Subject: Response to Nuclear Regulatory Commission Request of October 13, 1999, for Additional Information on Ground Water Compliance Action Plan and Alternate Concentration Limit Application for the Canonsburg, Pennsylvania, Title I Uranium Mill Tailings Site

Canonsburg GCAP/ACL NRC Request for Additional Information (RAI)

Revision of the Canonsburg ACL Application (Document Number U00358AA – September 1998) – this will replace Section 3.0 starting on page 43. This revision addresses Comment 2 in the NRC RAI of 13 October 1999. (Note – original color Figures 3-1 through 3-4 will be placed in the final version of the document).

Uranium Concentration

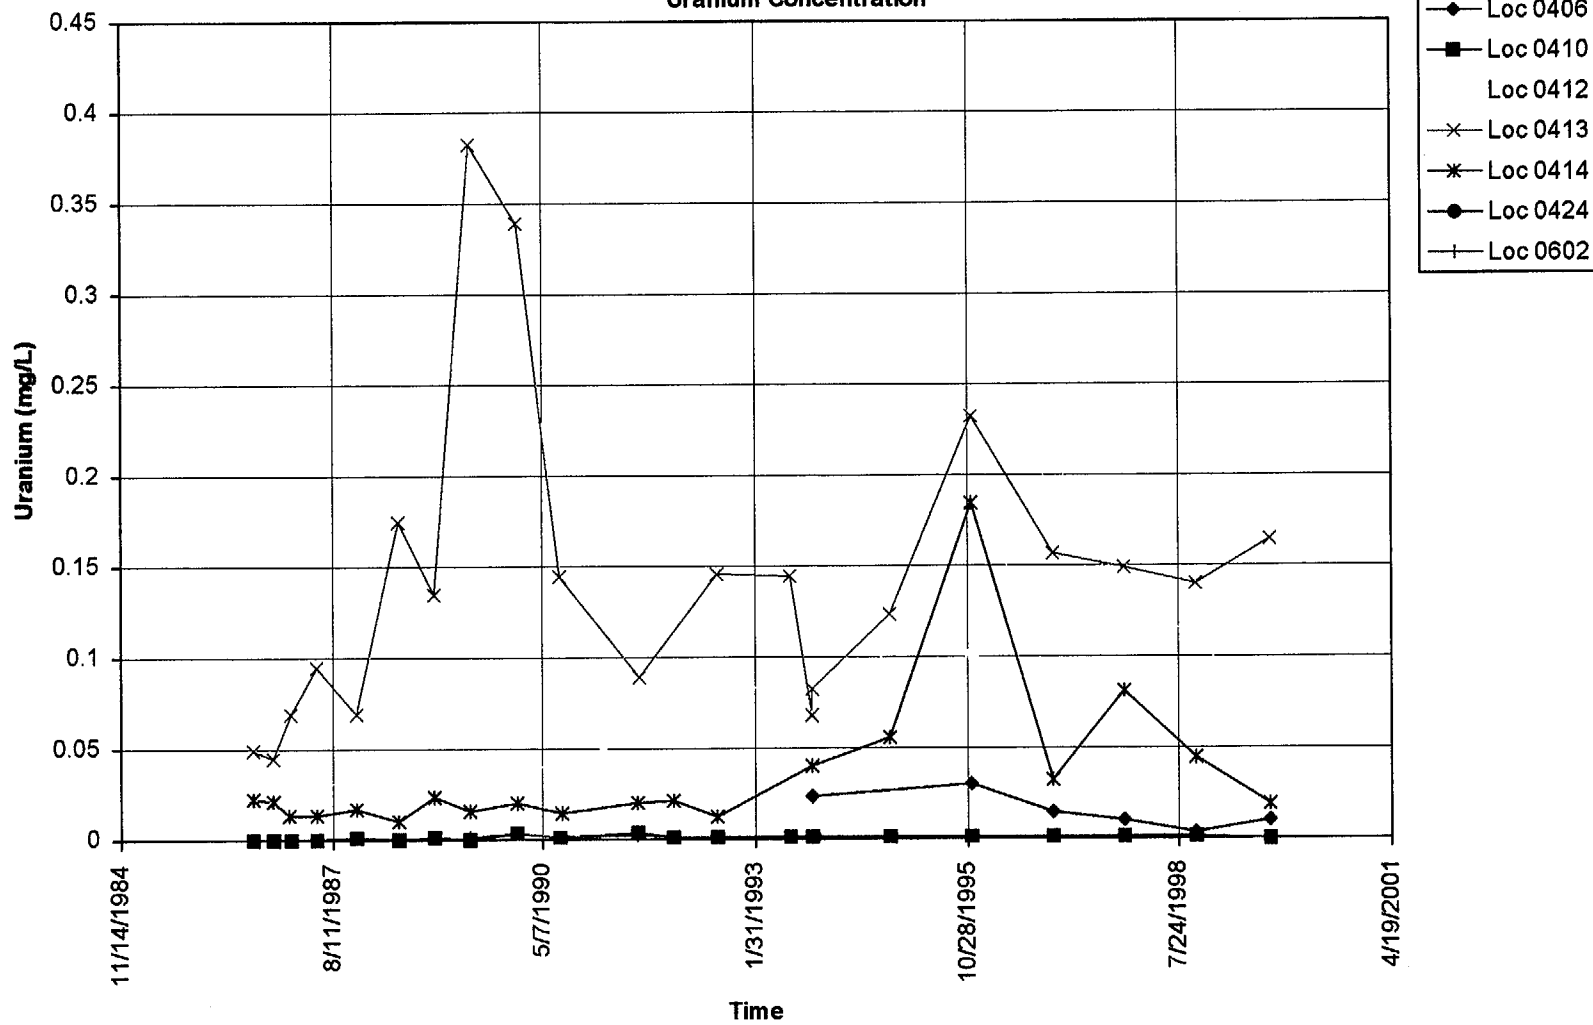
Since completion of remedial action at the Canonsburg site in the mid-1980s, concentrations of uranium in ground water downgradient from the disposal cell have increased through the mid-1990s, and are now generally on a downward trend (with minor anticipated fluctuations) (Figure 3-a). This is consistent with modeling predictions that concentrations will decrease over time. Although concentrations of uranium are still elevated above the MCL in ground water at two of the three POC wells, there is no potential impact to human health and the environment, and the concentrations are significantly below the proposed ACL (Section 4.1). Also, no uranium has ever been detected at the POE in surface water in Chartiers Creek.

maclec-ers		U.S. DEPARTMENT OF ENERGY GRAND JUNCTION OFFICE, COLORADO	
Potential Location for a Pump-and-Treat System at the Canonsburg Site			
DATE PREPARED:		FILENAME:	
December 16, 1999		U0042200-02

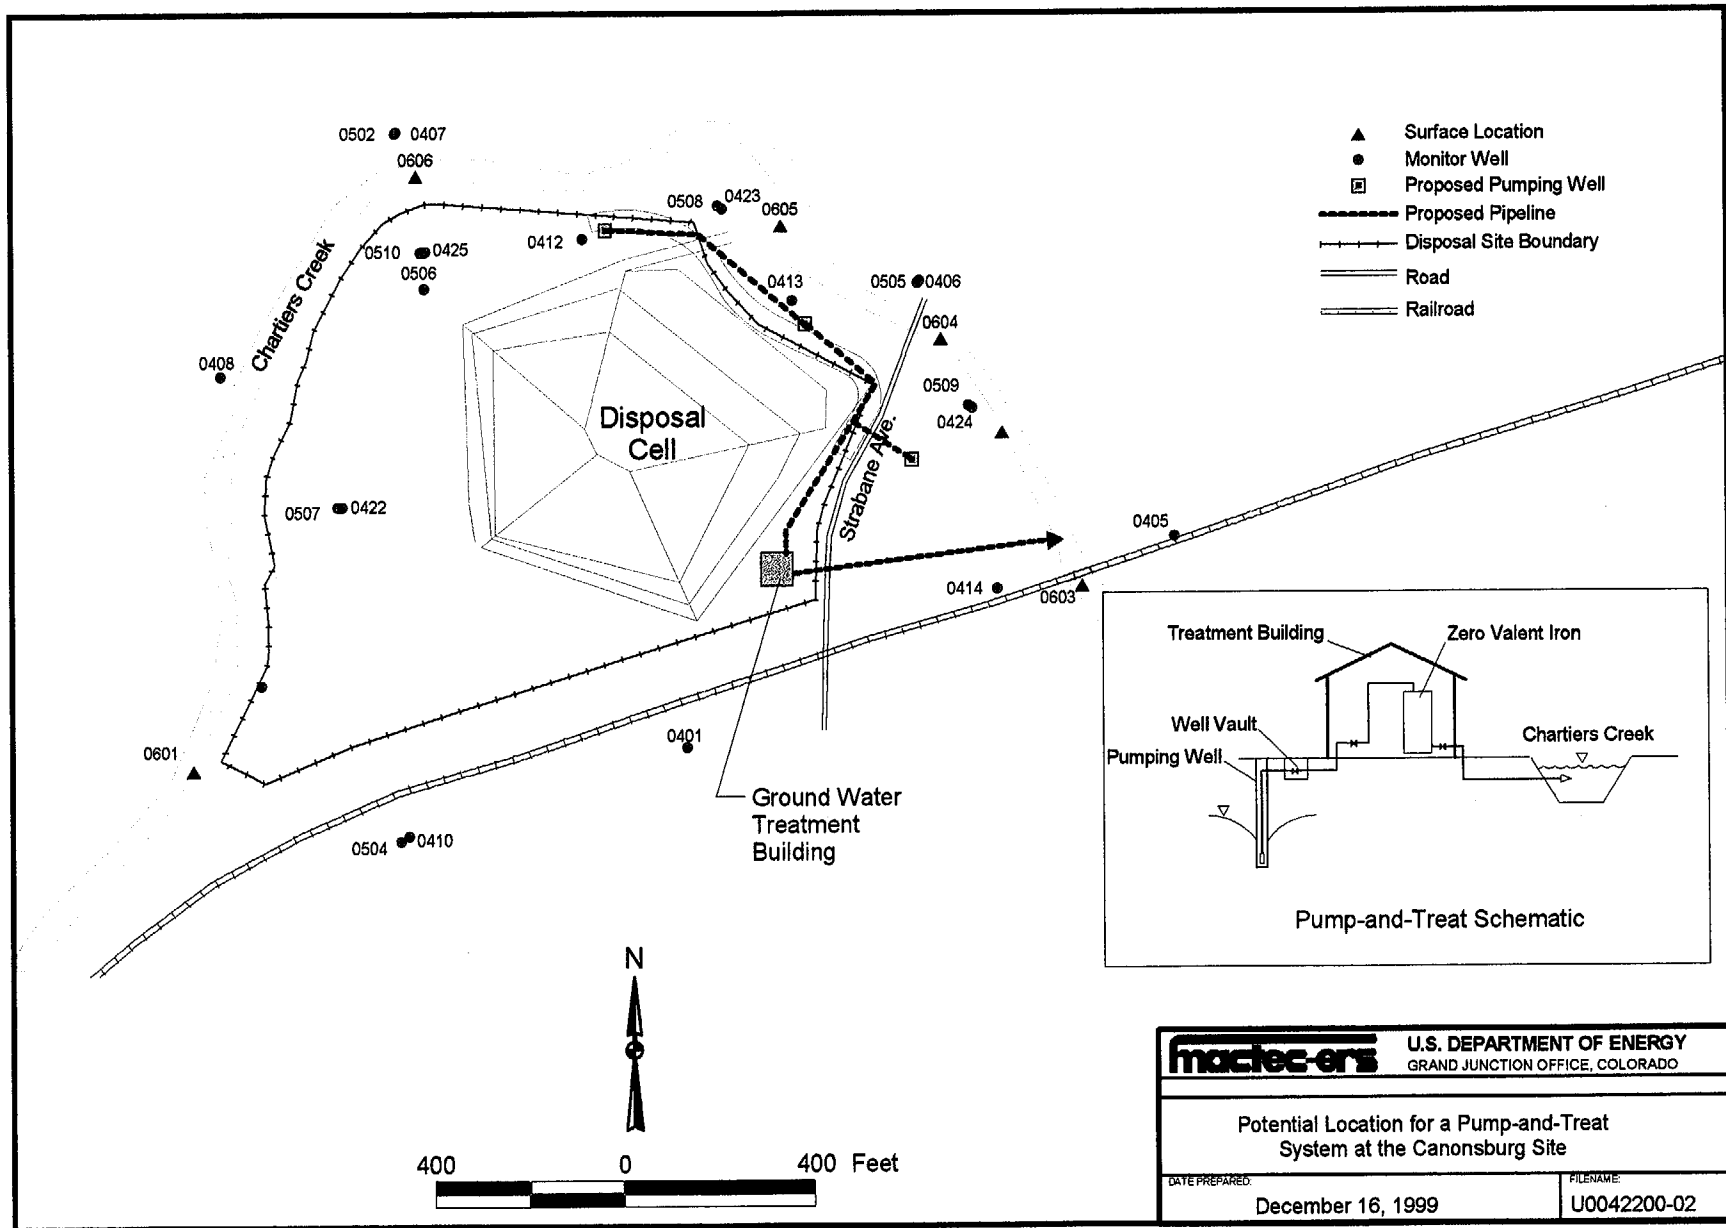
- Two pumping wells located downgradient from the disposal cell (the location of the disposal cell next to the creek is an obstacle to effective placement of the wells) (Figure 3-b).
- Pumping rates set at 10 gallons per minute in each well (it is unlikely that the wells could sustain this yield for extended periods of time).
- Duration of the pumping period set to 10 years.

Figure 3-1. Mean Concentration Distribution for Uranium 10 Years After Start of Pump-and-Treat Scenario (y008)

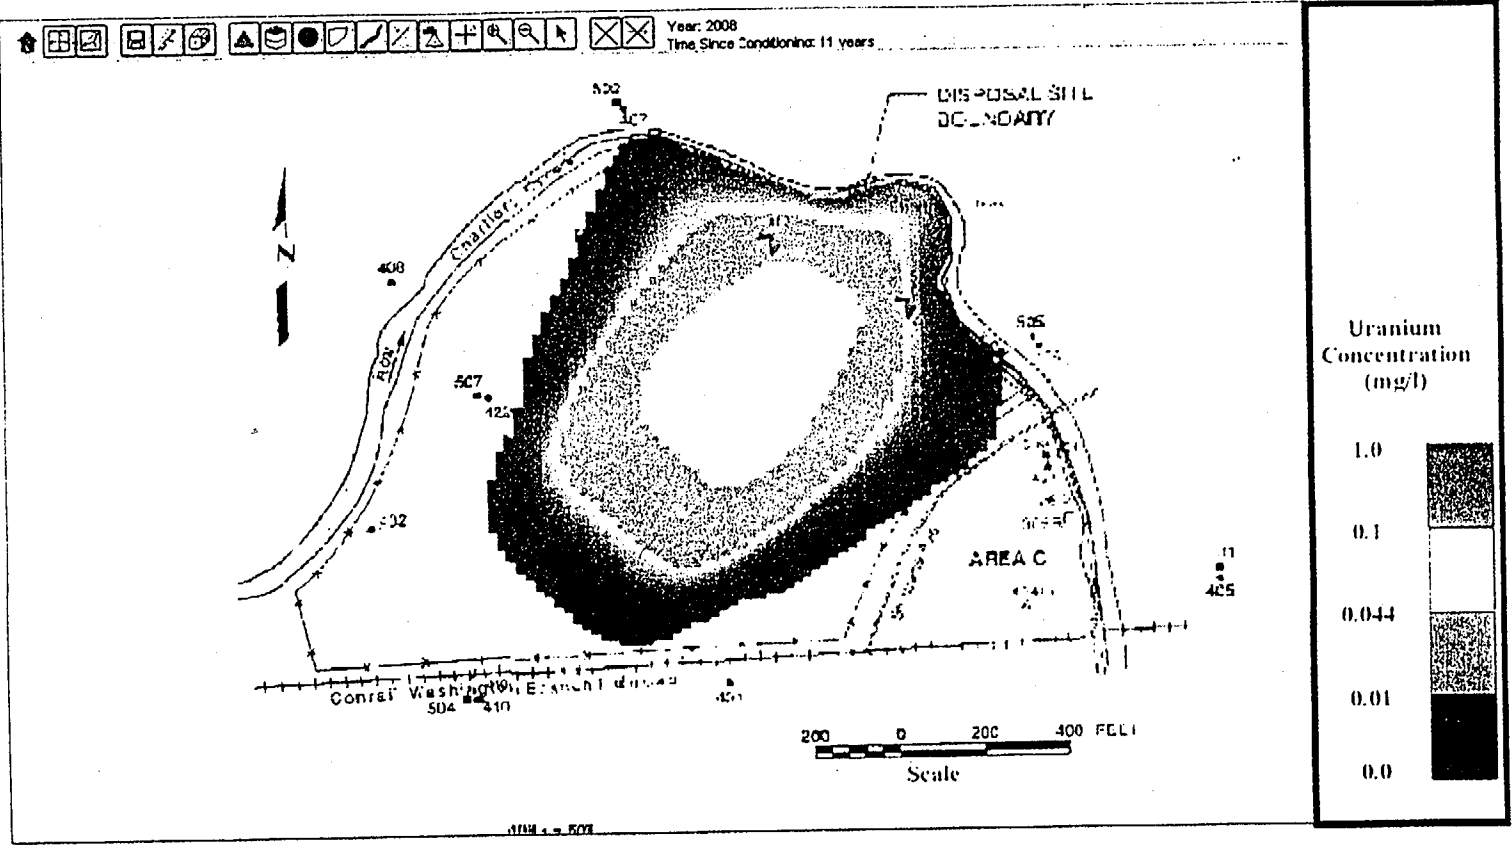
The modeling results suggest that a pump-and-treat scenario will do little to enhance the cleanup of the aquifer in a timely and cost-efficient manner. Figures 3-1 and 3-2 show the average concentration distributions of uranium at the site through time for the pumping scenario discussed above. Figures 3-3 and 3-4 show the probability distributions for the likelihood of concentrations being less than the MCL. Additional time frames are shown in Appendix C for both average concentration distributions and probability distributions in order to visualize the transient effects of a pump-and-treat scenario. From these simulation results it is likely that the pump-and-treat scenario will help clean up the site within 15 to 20 years.

mactec-ers		U.S. DEPARTMENT OF ENERGY GRAND JUNCTION OFFICE, COLORADO	
Potential Location for a PeRT Wall at the Canonsburg Site			
DATE PREPARED:		FILENAME:	
December 15, 1999		U0042200-01

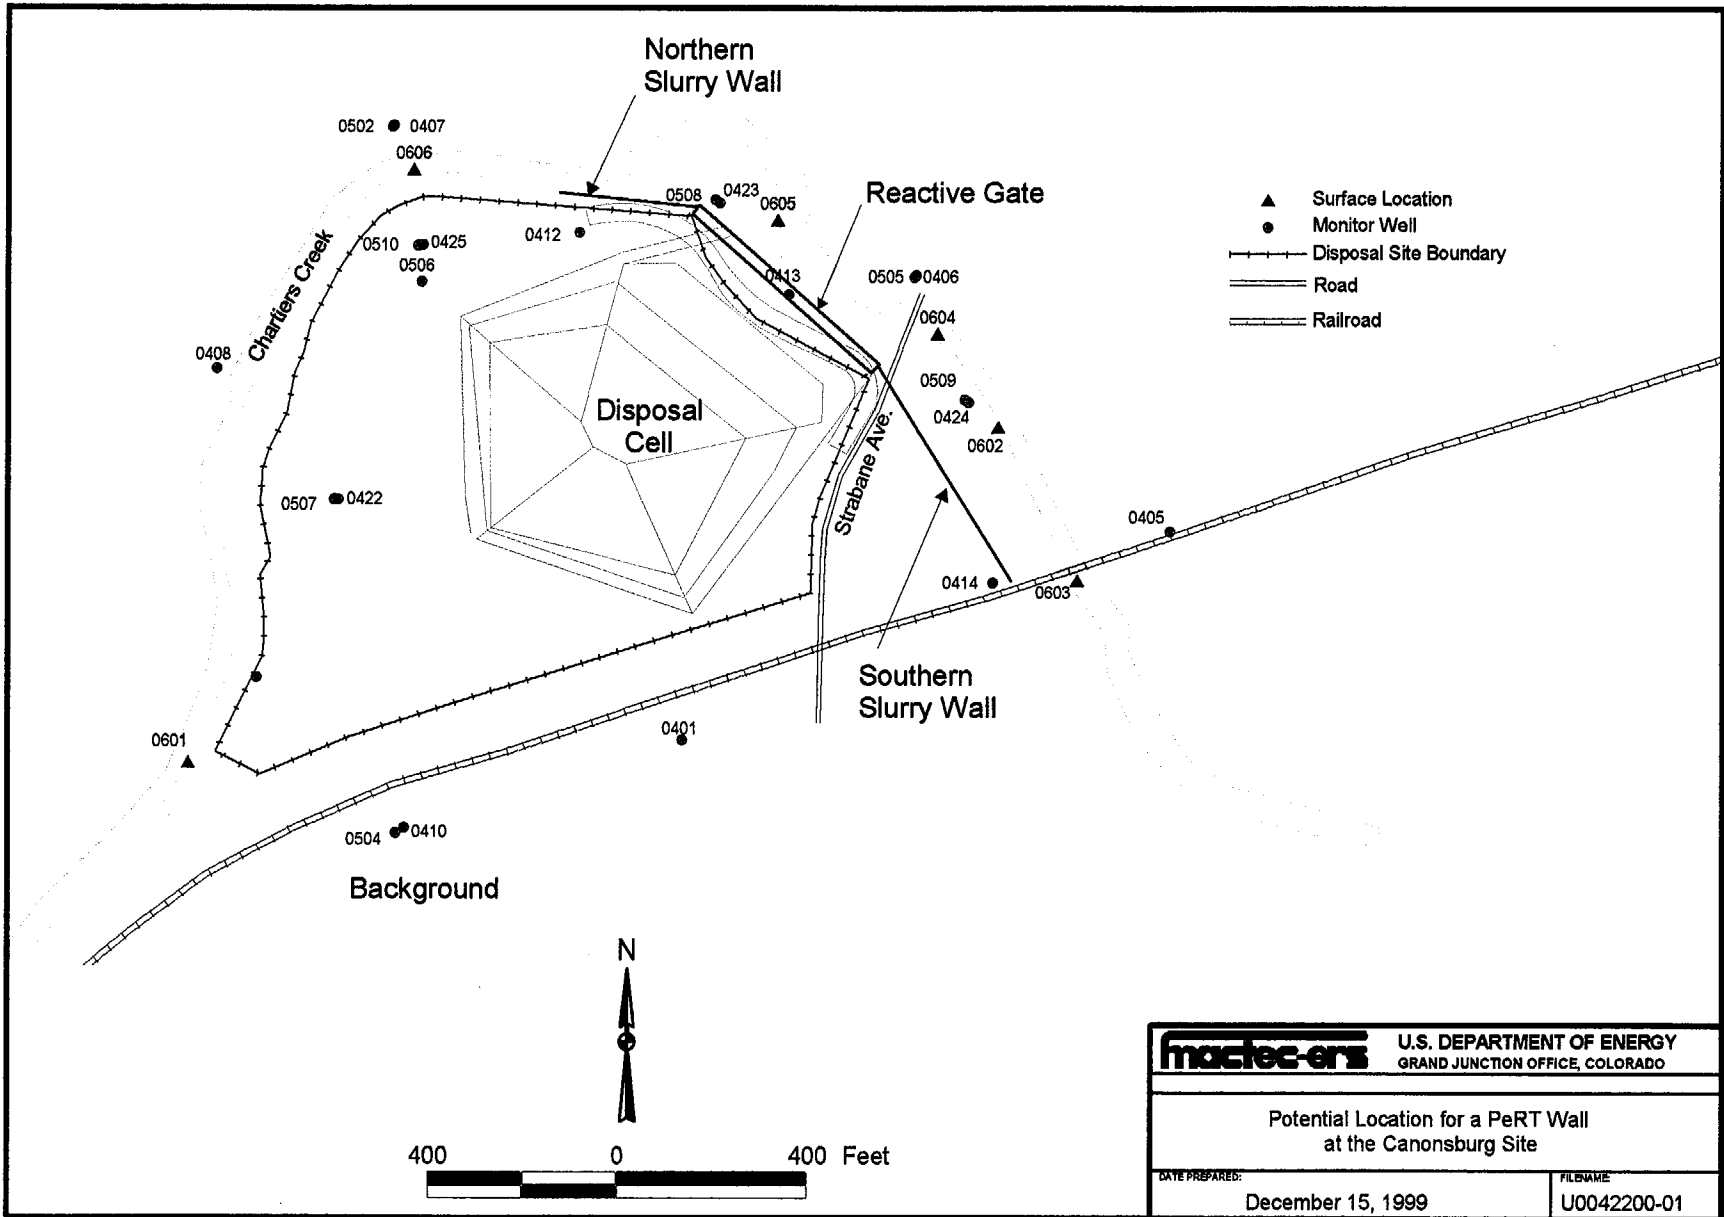
If a PeRT wall was constructed at Canonsburg, it would be emplaced between the disposal cell and Chartiers Creek (Figure 3-c). Because ground water flow is relatively low, a funnel and gate PeRT wall would be the most feasible. In this configuration, the gate is the reactive medium and the funnel is an impermeable material such as a bentonite/soil slurry wall. Contaminated water that contacts the impermeable portion is funneled to the reactive gate for passive treatment. Because of the low ground water flows at Canonsburg, only limited mounding is expected directly upgradient of the wall.

Based on the monitoring data, the most effective area for the PeRT wall would be between monitor wells 412 and 414 southwest of Chartiers Creek (Figure 3-c). The reactive portion of the wall would be directly downgradient of the encapsulation area. The southern impermeable wall would extend from just north of Strabane Avenue to monitor well 414. The northern impermeable wall would be from north of monitor well 412 to just west of monitor well 423. The bottom portion of this wall would be keyed into the bedrock. Based on a depth to ground water of approximately 5 feet below ground surface (bgs) and a depth to competent bedrock of approximately 25 feet bgs (including up to 10 feet of the weathered/fractured zone at the top of the bedrock) the vertical extent of the wall would be 20 feet.
